HISTORIC AND DESIGN REVIEW COMMISSION

December 19, 2018

HDRC CASE NO: 2018-474
ADDRESS: 7300 JONES MALTSBERGER RD
LEGAL DESCRIPTION: NCB 18208 BLK 8 LOT E 137.41 FT OF 1 (ALAMO CEMENT UT-3D)
ZONING: C-3,HS
CITY COUNCIL DIST.: 1
LANDMARK: Commercial Building
APPLICANT: Daniel Long
OWNER: Quarry Coyotes Ltd
TYPE OF WORK: Construction of an addition, exterior modifications
APPLICATION RECEIVED: November 30, 2018
60-DAY REVIEW: January 29, 2018
REQUEST:

The applicant is requesting a Certificate of Appropriateness for approval to:

Proposed Site Plan

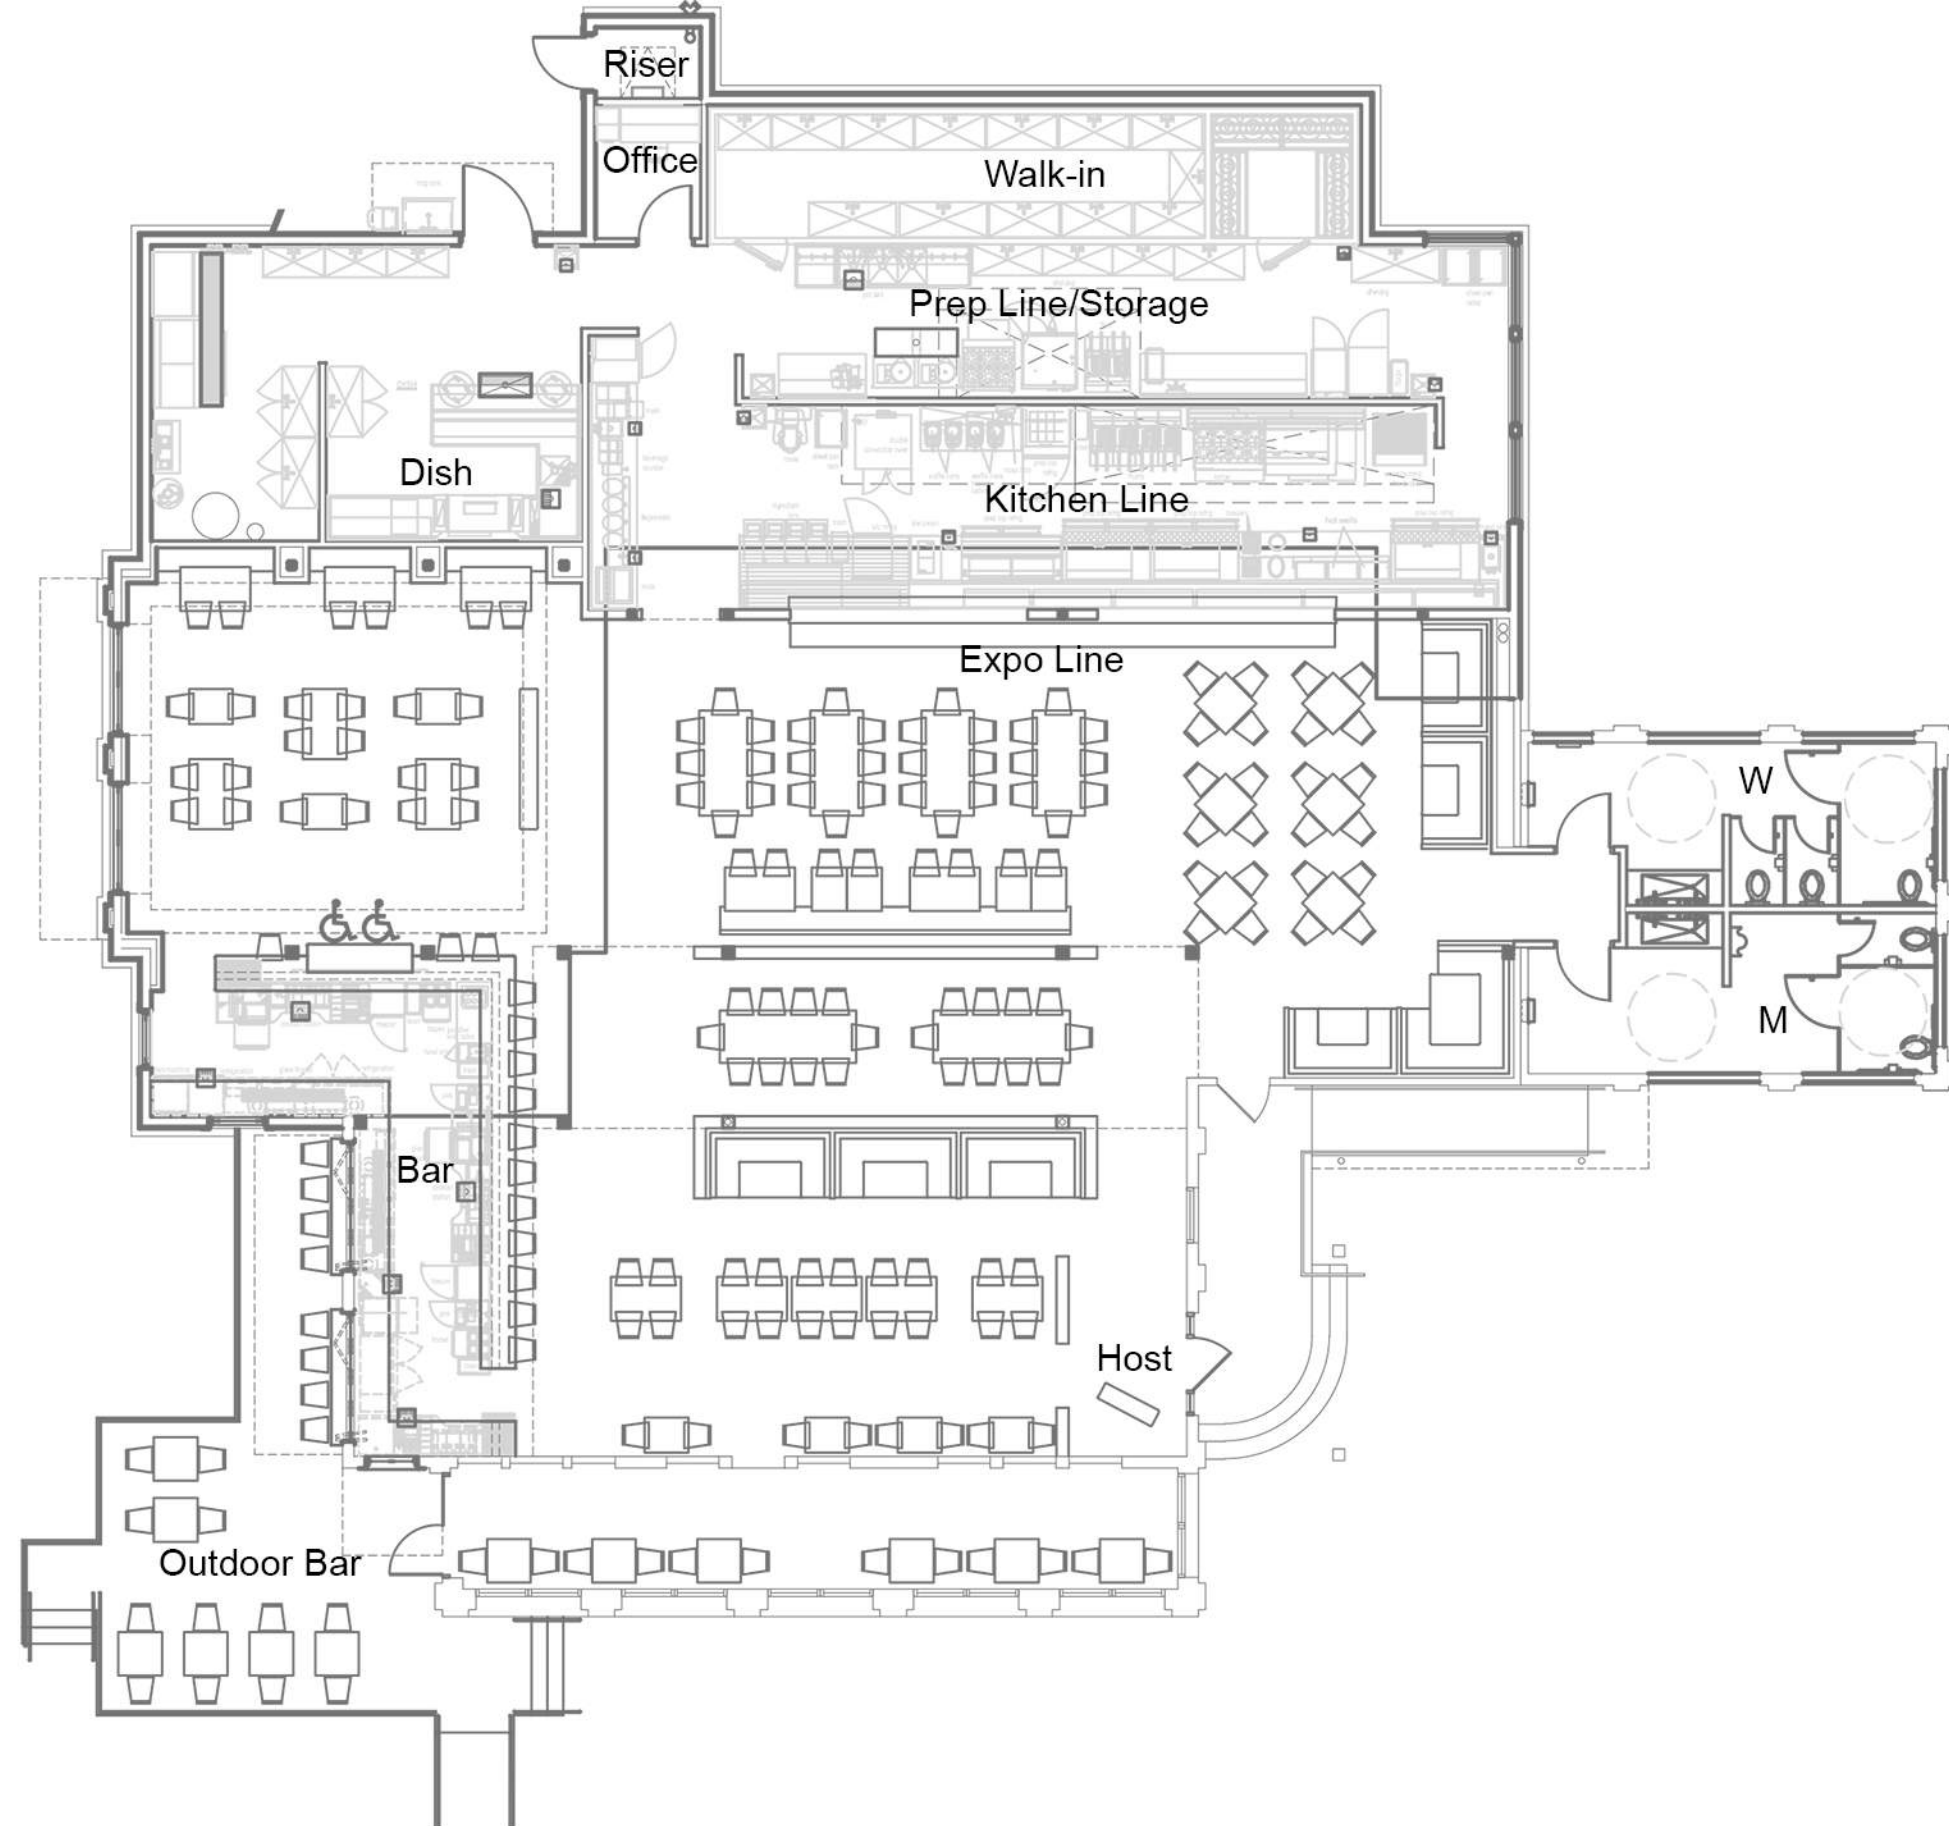
- m. FOUNTAIN – The applicant has not indicated any modifications to the historic fountain located to the southwest of the original structure.
- n. LANDSCAPING AND HARDSCAPING – The applicant has proposed to modify the existing hardscaping and landscaping to provide greater connectivity between the exterior patio spaces. Staff finds the proposal to be generally appropriate.

- o. AIRSTREAMS – The applicant has proposed to incorporate two freestanding airstreams on the southern portion of the site. According to the applicant, the airstreams will provide private seating and serve as an outdoor remote bar. Their placement will not affect any character defining landscape features or obscure the historic structure. Staff finds this acceptable with the stipulation listed in the recommendation.

- p. SIGNAGE – While a monument sign is indicated on the site plan, signage design information – such as height, material, lighting, color, and text information – has not been proposed as part of this application. The applicant is responsible for submitting a separate signage application for consideration by the Commission.
